Access Compliance Report

Public Rights-of-Way

(Curb Ramps)

Intersection ID: N/A	Main Street: MONROE_RD	Cross Street: BUFORD_AV	Location: SE
ADA ID: CC30B0593F52	Ramp Type: PerpDiag	Initial Pass/Fail: Fail	Overall Compliance: No
Codes/Mitigation Info/Possible Solution		Field Measurements/Component Compliance	
Severity Score: 21.25

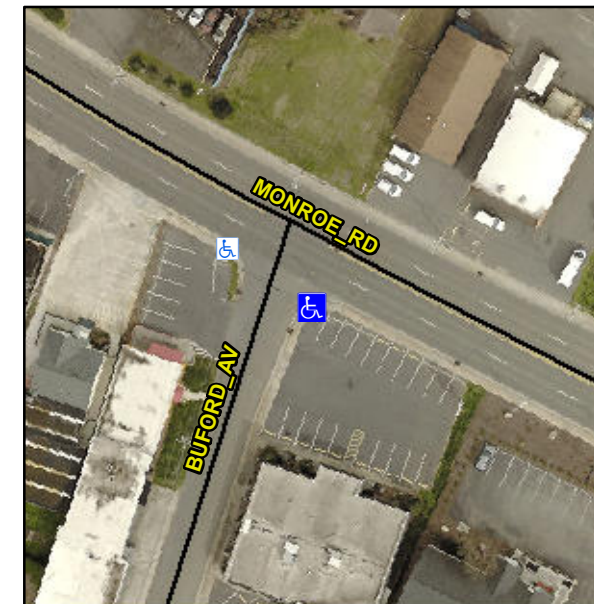
Not Found, R304.5.1, R304.2.2

Compliance	Description	Data	Compliance	Description	Data
N/A	Ramp Length (in)	49.0	No	Ramp Slope (%)	10.8
No	Ramp Width (in)	45.0	Yes	Ramp XSlope (%)	0.5
N/A	Flare Type LT	N/A	N/A	Flare Type RT	N/A
N/A	Flare Slope LT (%)	N/A	N/A	Flare Slope RT (%)	N/A
N/A	Flare Traversable LT?	N/A	N/A	Flare Traversable RT?	N/A
N/A	Landing Length (in)	N/A	N/A	DWS Provided?	N/A
N/A	Landing Width (in)	N/A	N/A	DWS Contrast?	N/A
N/A	Landing Slope (%)	N/A	N/A	DWS Length (in)	N/A
N/A	Landing X Slope (%)	N/A	N/A	DWS Full Width?	N/A
N/A	Landing Curb? (Y/N)	N/A	N/A	DWS Offset (in)	N/A
N/A	Shared Landing?	N/A			
N/A	Gutter Ponding?	N/A	N/A	Gutter Slope (%)	N/A
N/A	Gutter Lip Ht (in)	N/A	N/A	Gutter X Slope (%)	N/A
N/A	Painted X Walk1?	No	N/A	Painted X Walk2?	No
	X Walk 1 Direction	To NE		X Walk 2 Direction	To NW
N/A	X Walk 1 Width (in)	N/A	N/A	X Walk 2 Width (in)	N/A
	X Walk 1 Slope (%)	3.0		X Walk 2 Slope (%)	1.2
	X Walk 1 X Slope (%)	0.4		X Walk 2 X Slope (%)	1.8

Remove & Replace Curb Ramp With Two New Directional Ramps or Equivalent.
